SERVICE BULLETIN

SERVICE BULLETIN		No.: ESB-96E33-504																			
		Date: 1997-02-28	<Model> ECLIPSE(D30) <M/Y> 96-10																		
Subject:	CORRECTION OF SPECIFICATION FOR LATERAL LOWER ARM BALL JOINT STARTING TORQUE																				
Group:	FRONT SUSPENSION																				
Correction	 O. Kai - E.V.P. After Sales Service																				
1. Description: The standard starting torque values for lateral lower arm ball joint in the manual Indicated below are required to be corrected according to this Service Bulletin.																					
2. Applicable Manual:

SERVICE SPECIFICATIONS

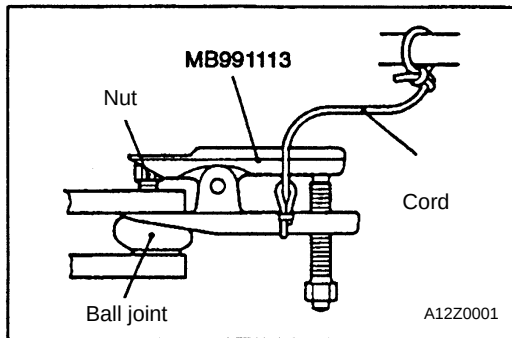
Items		Standard value
Toe-in	At the centre of tyre tread mm	0±3
	Toe-angle (per wheel)	0° ± 0°09'
Toe-out angle on turns (inner wheel when outer wheel at 20°)		22.3°
Camber		-0°05' ± 30'
Caster		4°40' ± 1°30'
Kingpin inclination		7°45' ± 1°30'
Upper arm ball joint starting torque Nm		0.3 - 1.5
Compression lower arm ball joint starting torque Nm		0.5 - 2.5
Lateral lower ball joint starting torque Nm		~~1.0 - 3.5~~ <Incorrect>
Stabiliser link ball joint starting torque Nm		0.5 - 1.5

<Correct>

1.5 or less

BALL JOINT STARTING TORQUE CHECK

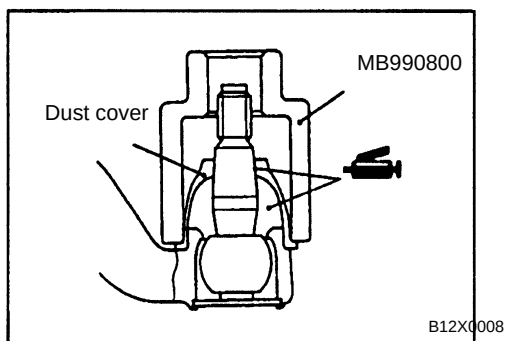
Standard value: 0.5-2.5 Nm **<Deleted>**

Lateral lower arm ball joint [~~When load is 3727 N~~]

Standard value: ~~1.0-3.5 Nm~~ **<Incorrect>**

<Correct>

1.5 Nm or less
